Access Compliance Report

Public Rights-of-Way

Intersection ID: 29307	Main Street: OAKDALE_GREEN_DR	Cross Street: WANDERING_CREEK_DR	Location: SE
ADA ID: 4423C3E718AD	Ramp Type: Perp	Initial Pass/Fail: Fail	Overall Compliance: No
Severity Score: 33.75			
Codes/Mitigation Info/Possible Solution		Field Measurements/Component Compliance

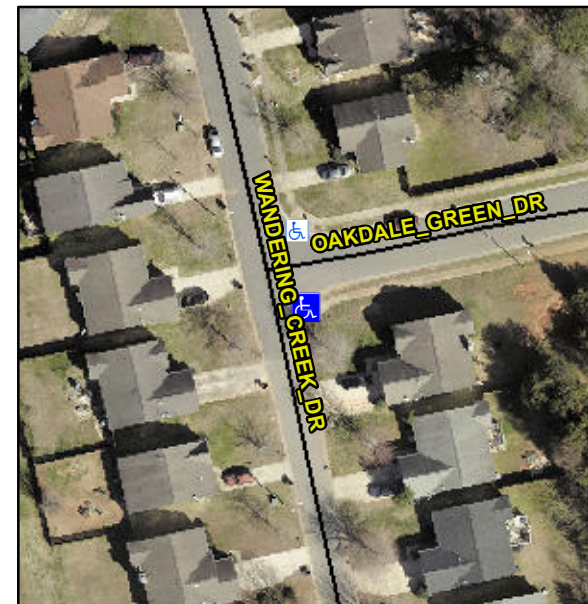
Not Found, R304.5.1, R304.5.3

Compliance	Description	Data	Compliance	Description	Data
N/A	Ramp Length (in)	49.0	Yes	Ramp Slope (%)	5.2
No	Ramp Width (in)	38.0	No	Ramp XSlope (%)	7.0
N/A	Flare Type LT	N/A	N/A	Flare Type RT	N/A
N/A	Flare Slope LT (%)	N/A	N/A	Flare Slope RT (%)	N/A
N/A	Flare Traversable LT?	N/A	N/A	Flare Traversable RT?	N/A
N/A	Landing Length (in)	N/A	N/A	DWS Provided?	N/A
N/A	Landing Width (in)	N/A	N/A	DWS Contrast?	N/A
N/A	Landing Slope (%)	N/A	N/A	DWS Length (in)	N/A
N/A	Landing X Slope (%)	N/A	N/A	DWS Full Width?	N/A
N/A	Landing Curb? (Y/N)	N/A	N/A	DWS Offset (in)	N/A
N/A	Shared Landing?	N/A			
N/A	Gutter Ponding?	N/A	N/A	Gutter Slope (%)	N/A
N/A	Gutter Lip Ht (in)	N/A	N/A	Gutter X Slope (%)	N/A
N/A	Painted X Walk1?	No	N/A	Painted X Walk2?	N/A
	X Walk 1 Direction	To N		X Walk 2 Direction	N/A
N/A	X Walk 1 Width (in)	N/A	N/A	X Walk 2 Width (in)	N/A
	X Walk 1 Slope (%)	0.2		X Walk 2 Slope (%)	N/A
	X Walk 1 X Slope (%)	5.3		X Walk 2 X Slope (%)	N/A

Remove & Replace Entire Ramp.
